No. 2006-04(W)

**MODELS:** 2006 Evinrude® E-TEC® 40DRLSD  
(40 HP Rope Start Tiller Models with or without an electric start kit added)

**SUBJECT:** Start in Gear

# SAFETY RECALL NOTICE

1. Mark

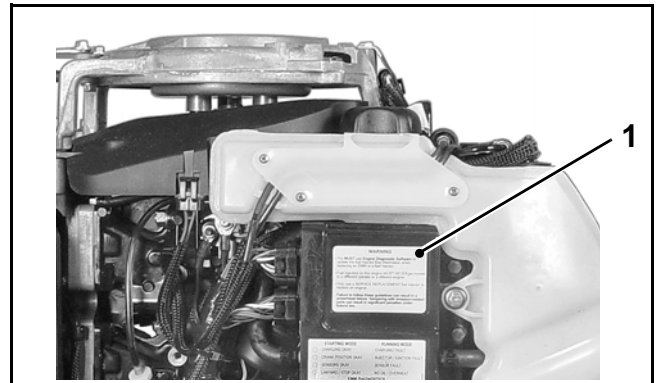
Remove the engine cover and inspect EMM for mark as shown below. If the mark is present the “Set Engine Type” switch has been changed. If NO mark is present use Evinrude Diagnostics to change.

1. Settings screen, Evinrude Diagnostics  
2. Set Engine Type

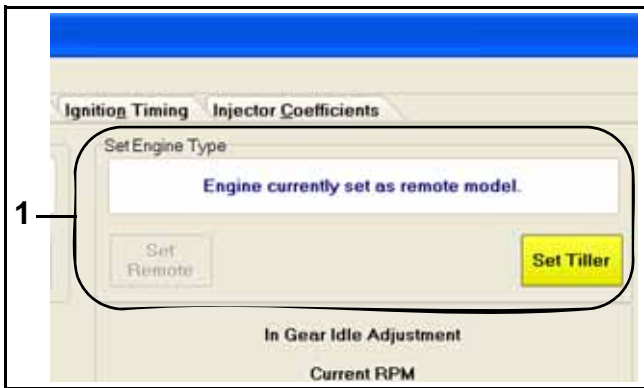
Use Evinrude Diagnostics software program to view the EMM “Settings” screen. Verify setting at “Set Engine Type.”

Use *Evinrude Diagnostics* software program to change “Engine Type.” If display reads “Engine currently set as remote model,” click the “Set Tiller” button on the screen.

1. Mark

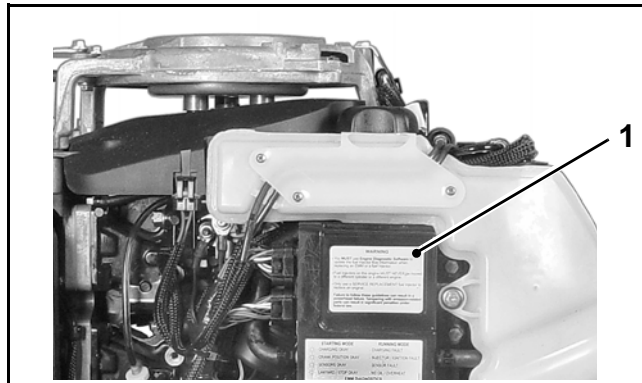
Use a BLACK permanent marker to mark the *EMM* as shown below to indicate the switch change was performed.
